REMARKS

Application No. 09/927,945 Amendment dated October 7, 2004 Reply to Office Action of July 9, 2004 Annotated Sheet Showing Changes

[Fig. 4b]

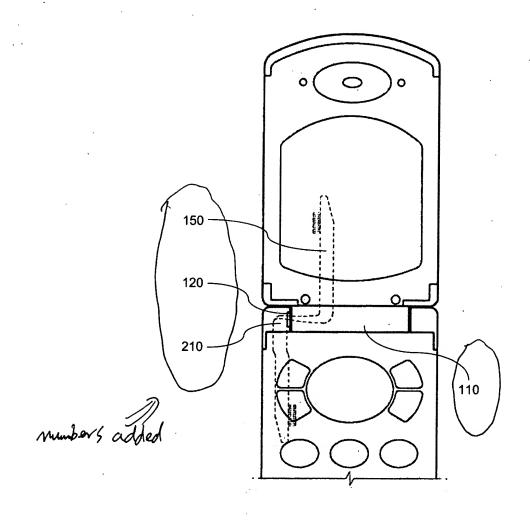
The Office Action indicates that new corrected drawings are required because Fig. 4b does not have any lebels to identify the elements.

Fig. 4b is amended as shown above adding reference numerals and new Fig. 4b is being submitted herewith.
